Office Action Summary	Application No. 10/815,149	Applicant(s) VANDENBROEK ET AL.	
	Examiner THOMAS MCEVOY	Art Unit 3731

DETAILED ACTION

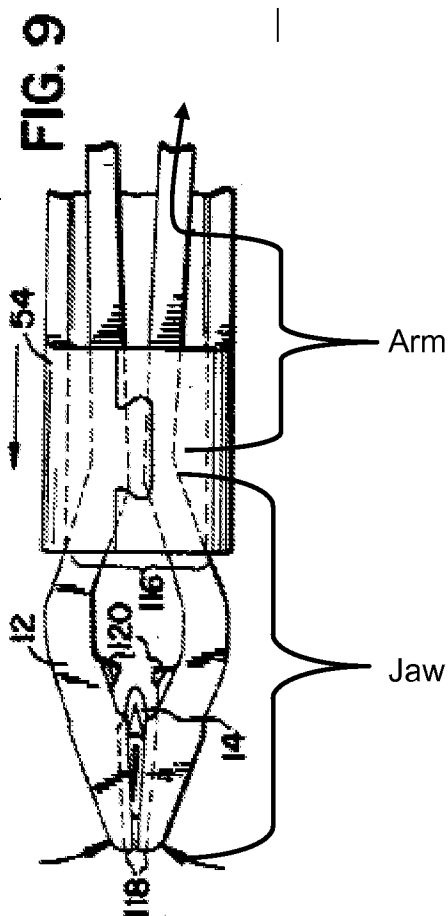
6. Claims 10-18 are rejected under 35 U.S.C. 102(a) as being anticipated by Yawata et al. (WO 2004/008944 A2).

Regarding claim 10, Yawata et al. disclose a jaw assembly adapted for use with a handle assembly in a surgical clip applier, comprising: a pair of jaws, 134a and 134b, adapted to receive a surgical clip, the jaws are movable between an open state and a closed state (p. 11, lines 5-6); a pair of elongate support arms, 132a and 132b, each adapted to support an associated one of the jaws between the open state of the jaws and the closed state of the jaws; a bridge 130 (Figure 10) disposed between the support arms to hold the jaws in an aligned relationship between the open state and the closed state; a housing, 101 and 102, disposed over at least the bridge, the housing having a

generally fixed relationship with the bridge while permitting movement of the jaws between the open state and the closed state; and a coupling (bottom surface of 101 which contacts scissors) included in the housing, the coupling being adapted for attaching the housing to the handle assembly. Regarding claim 11, the jaw, support arms and bridge contact each other and are integral. Regarding claim 12, the claimed phrase "wherein the housing the molded over the bridge" is being treated as a product by process limitation; that is, as set forth in MPEP 2113, product by process claims are not limited to the manipulation of the recited steps, only the structure implied by the steps. Once a product appearing to be substantially the same or similar is found, a 35 USC 102/103 rejection may be made and the burden is shifted to applicant to show an unobvious difference. MPEP 2113. The housing, 101 and 102, is found to be substantially the same or similar to the claimed housing. Regarding claims 13 and 14, the jaws are resilient and biased in the open position (p. 11, lines 5-6). Regarding claims 15-18, the jaws open and close in a plane separating the top and bottom surfaces of the arms. In a closed state, only the top and bottom surfaces of the arms can be in contact with the top and bottom sides of the housing (first and second portions) and the side surfaces can be squeezed out of contact with the side surfaces of the housing.
